Essroc - San Juan Carretera #2, Km. 26.7 Bo. Espinosa Dorado, Puerto Rico 00646 Tel 787-883-3500 Fax 787-883-5747 essroc.com us.i-nova.net

Essroc San Juan Cement
Compliance Evaluation Inspection, May 29, 2015 and
Consent Decree (3:09-cv-0 1578)

Individual Permit No. PR0001163 and MSGP 2008 Tracking No. PRR05BJ45

As requested in your last correspondence, we are hereby submitting our response to items included on the CEI report dated 09/11/2015 and that was received in our facility by 09/25/2015. The report was generated after an audit performed in our facility on May 29th, 2015 related to the compliance with Essroc San Juan's (ESJ) NPDES and MSGP permits of reference.

Weather Station at Essroc San Juan

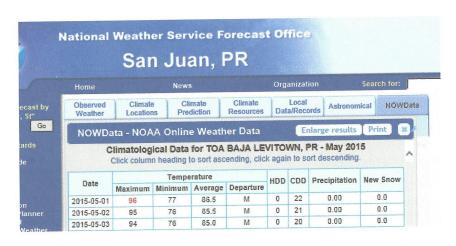
3. "Essroc's rain gauge was said not to be working and instead were using the National Oceanic and Atmospheric Administration (NOAA) website to obtain precipitation data for the plant. As required by paragraph 14.a of the Consent Decree, Essroc is required to conduct precipitation monitoring on site and is therefore not complying with its obligations under the CD. Also, EPA was on-site on May 29. 20 15 when there was an afternoon rain event. Essroc's precipitation log included in its Quarterly Report dated July 30, 2015 indicates that there was 0" of rain fall on May 29 and 1.63" on May 30, 2015. Please explain this discrepancy."

On 2012 ESJ acquired a weather station to be able to monitor rain data at the site. For unknown reasons the weather station was not installed before. The weather station was installed on top of the Technical Resources building on early August this year and was put in operation on August 14th. Rain data submitted on DMR reports after August 14th is data collected at the site by the weather station. We are including a picture of the weather station.

Regarding rain data for May 29th and 30th, although there was rain at the site on May 29th we didn't have at that time a way to measure rainfall at the site. As we state in our DMR reports, rain data was taken from the NOAA site, specifically from the Toa Baja, Levitown station. Levitown is located about 8.5 miles north-east of ESJ site. Without having s better source for rainfall data, ESJ kept using this as its source for the most representative rain data at the moment.

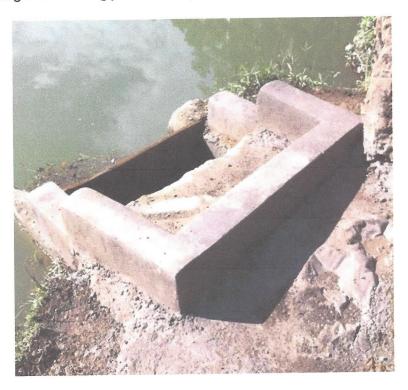
6. "As shown in Photos 731 to 737, there is a channel that conveys wastewater from a residential area (Guarisco Community) to Essroc's Pond No.2 which is tributary to Outfall 001...

Essroc should also consider other alternatives such as potentially obtaining sanitary sewer service for the Essroc Plant along with the adjacent unsewered community. For example, there is another community (Los Montes Residential Development) located within 1,000 feet of Guarisco Community that has sanitary sewer service."

ESJ has made studies in the past to evaluate alternatives to dispose it sanitary waters. Alternatives evaluated were; a. Connecting to Los Montes sanitary line, b. Connecting to a manhole at Road No.2 to Vega Alta Plant, and; c. Connecting directly to PRASA's Dorado plant. At the moment of the study all three options were discarded because of being either technically or economically unfeasible. From the 3 options, the more realistic was connecting to Los Montes sanitary line but for the moment it is not legally attainable since Los Montes sanitary line is still held as private because it was originally built by the developer.

On recent communications with the Dorado municipality ESJ found that there are no plans on the near future for the construction of any sanitary lines for the adjacent Guarisco community either.
